# IC Corporation

## AUTHORIZED FIELD CHANGE

AFC # 03401

Subject File: Caliper Slide Pin Bolts

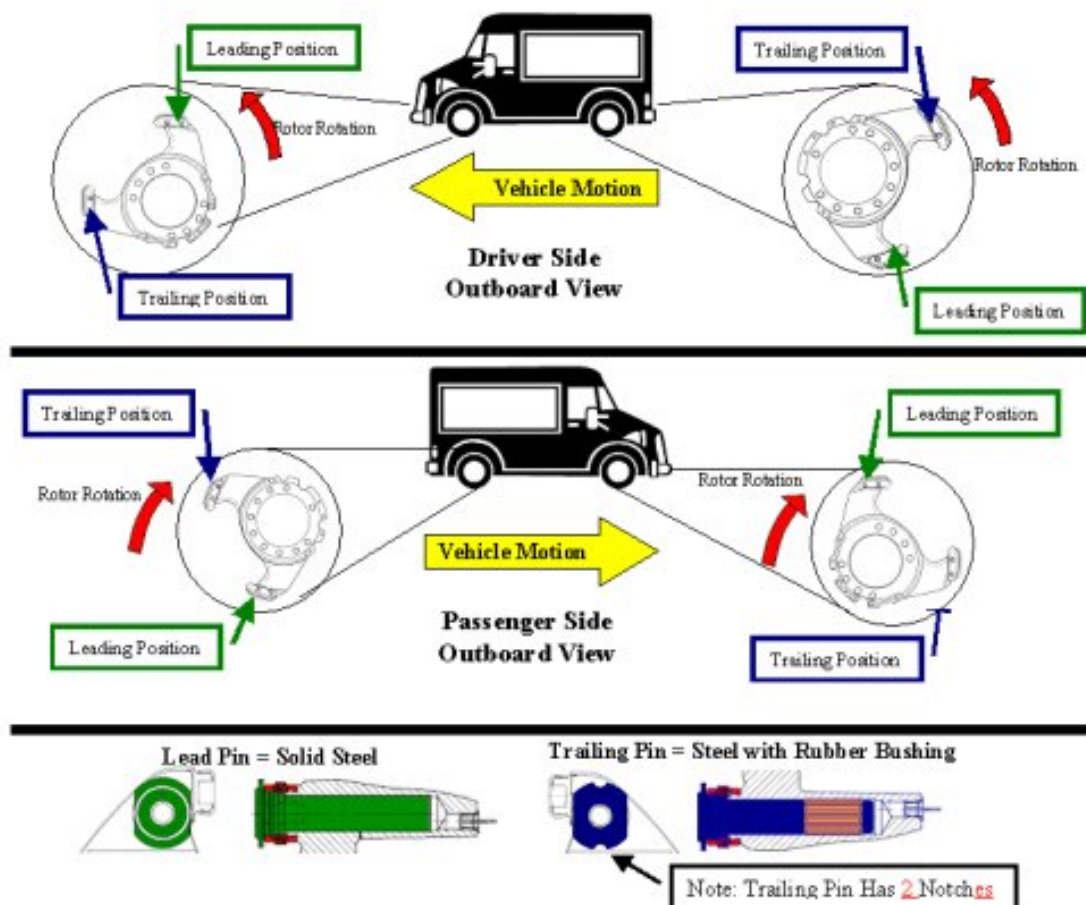
- e. See the following diagram for defining leading and trailing caliper mounting bolts.
5. Once all of the pin bolts have been inspected and/or replaced, lower the vehicle and remove the wheel chocks as necessary.

- a. Install new upper (top) mounting bolt FINGER tight securing the caliper to the anchor plate.
  - b. Then install new lower mounting bolt FINGER tight.

- c. FIRST, tighten the **leading** caliper mounting bolt to **93-107 Lb-Ft (126-145 Nm)**.
  - d. NEXT, tighten the **trailing** caliper mounting bolt to **93-107 Lb-Ft (126-145 Nm)**.
